Car Stereo
Service Bulletin

Model: CDX-R88

No. 132

Subject: Eject or No Playback After Loading **Date:** May 8, 1989

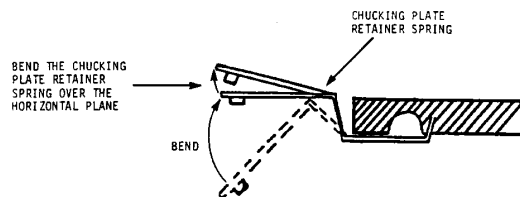
- A. Due to severe damage caused by transportation, the chucking plate may suddenly move so that its retainer spring shifts underneath the plate.
- B. A longer screw may have been used to install the unit in the car instead of the one supplied so that the DC/DC converter or the metal lever may be damaged.

Solution: A. Bend the retaining spring of the chucking plate as shown:

Bend the chucking
plate retainer
spring over the
horizontal plane

Chucking plate
retainer spring
Bend
